200SX Caliper Mounting Bracket Modifications

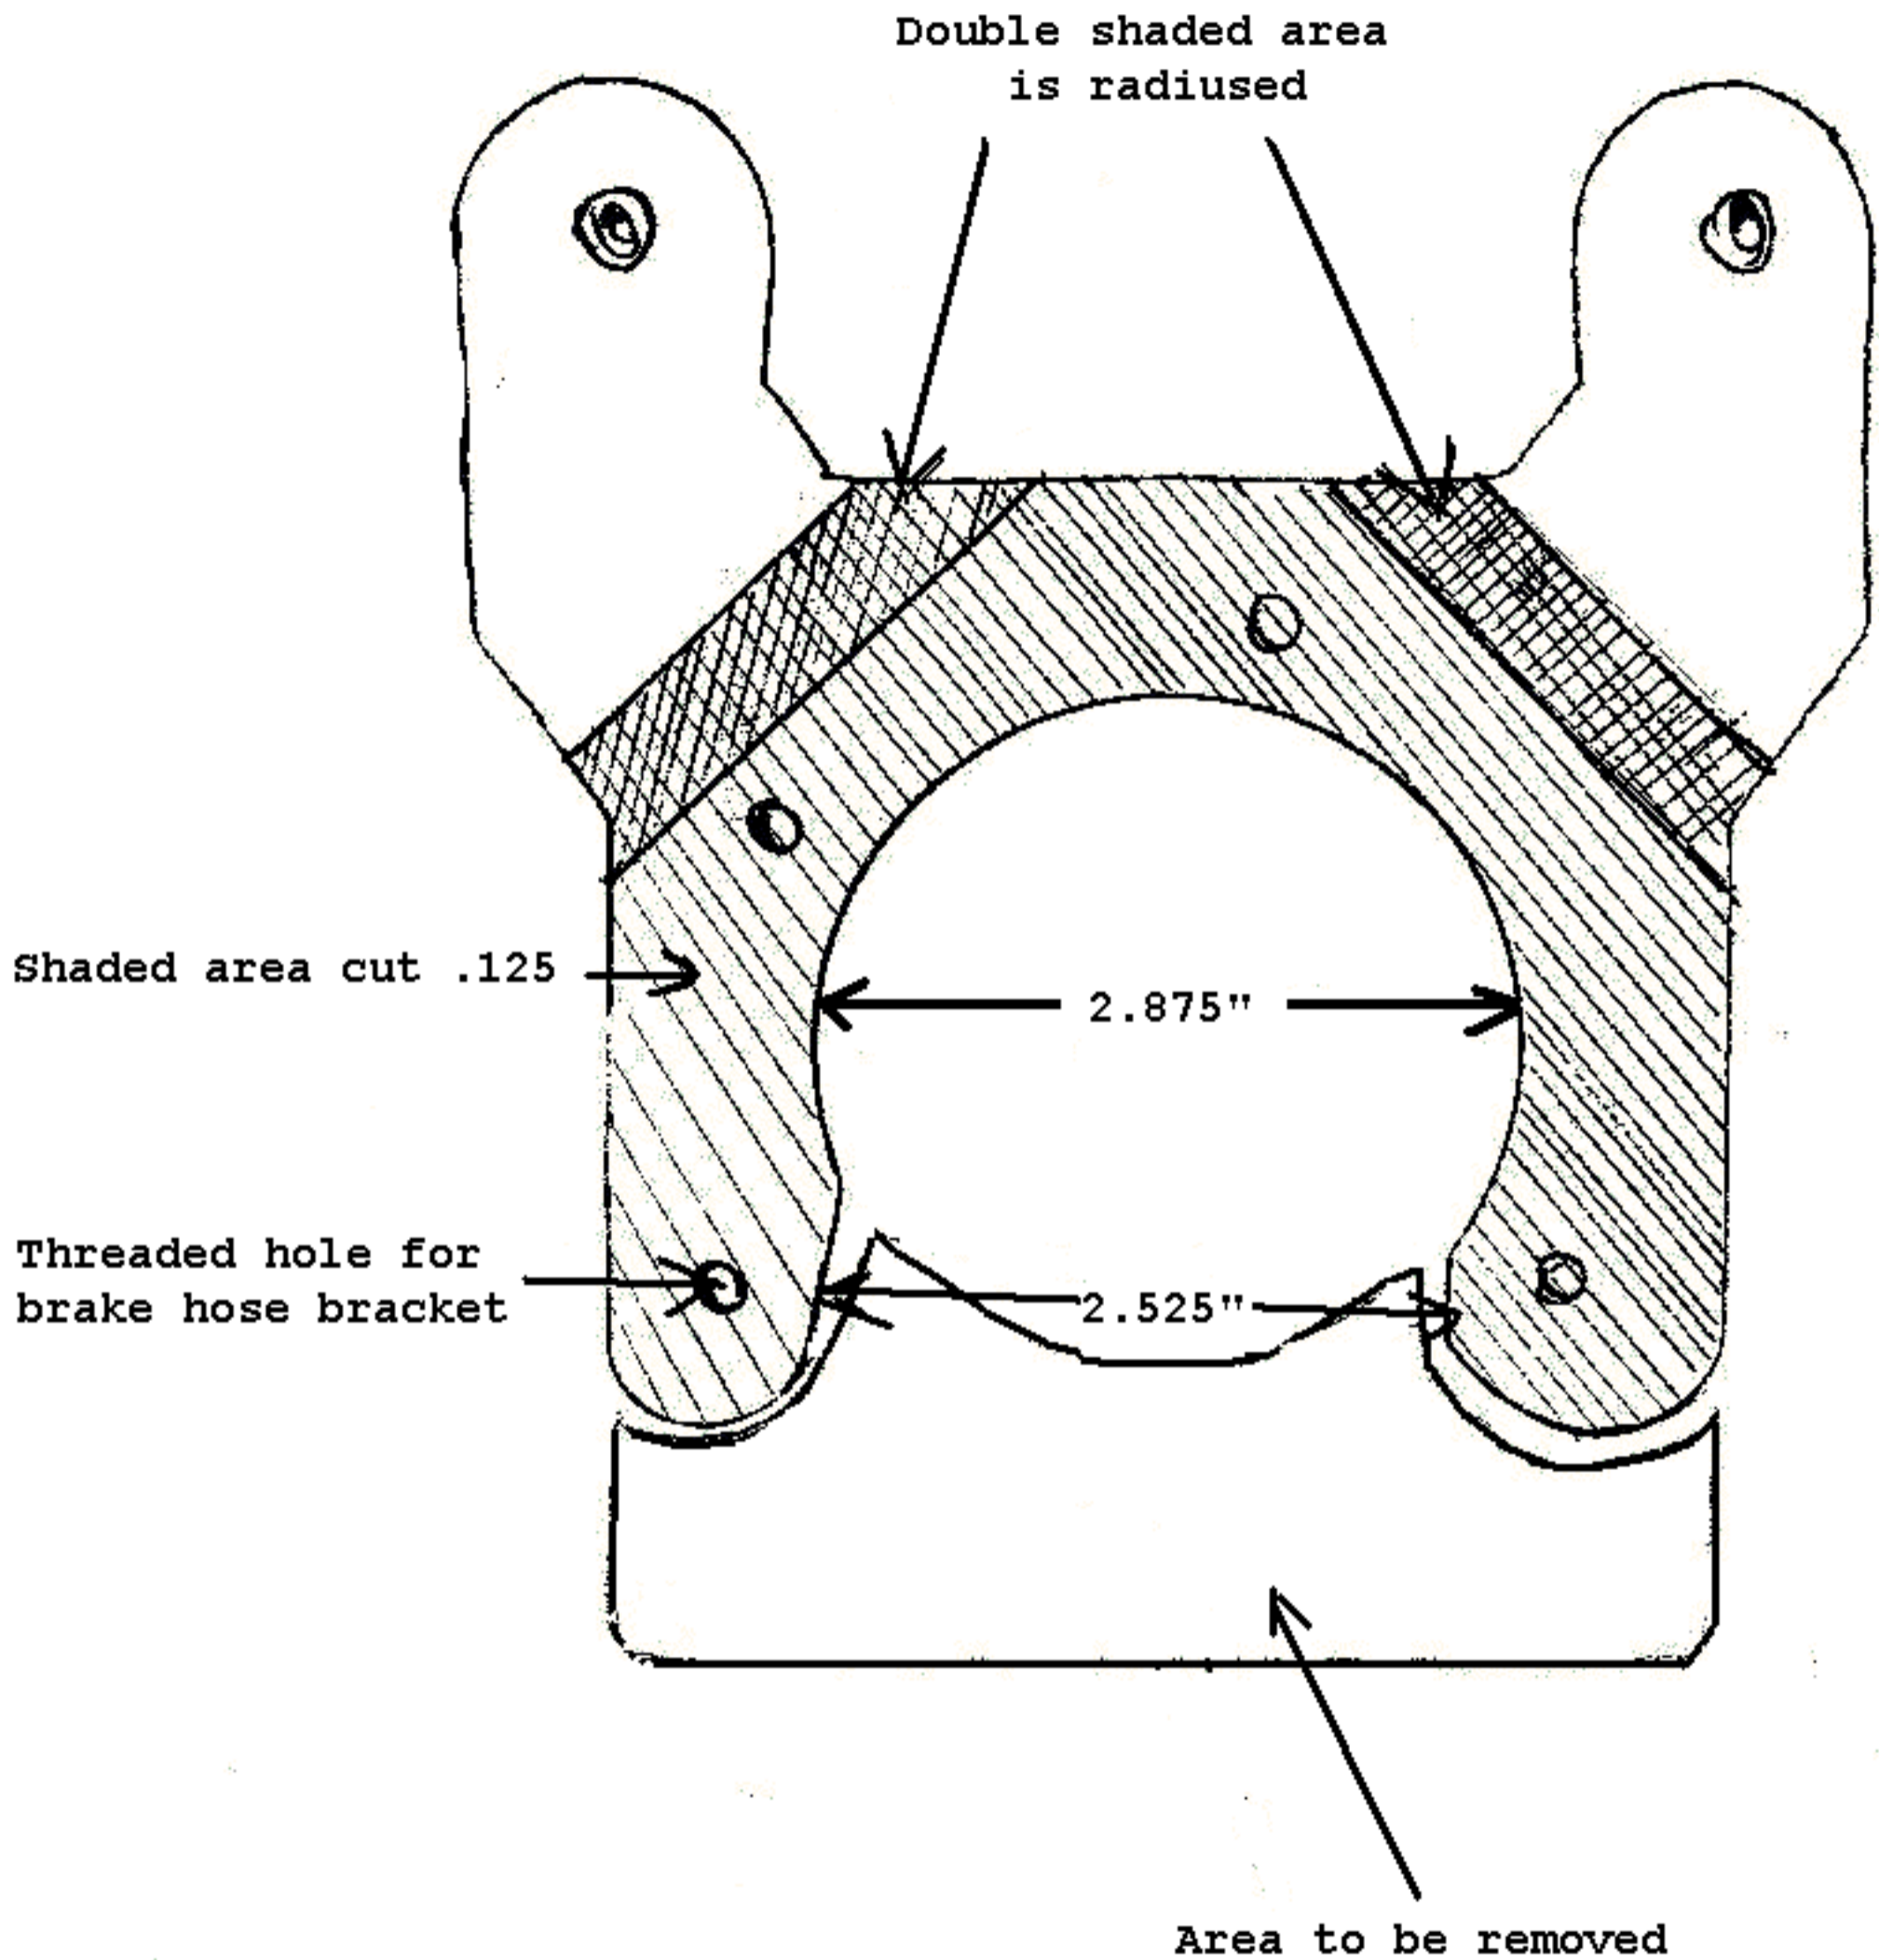
Bracket is originally about .460 thick

Shaded area cut .125 so caliper lines up with rotor

Need to remove area so bracket can slip around roadster axle
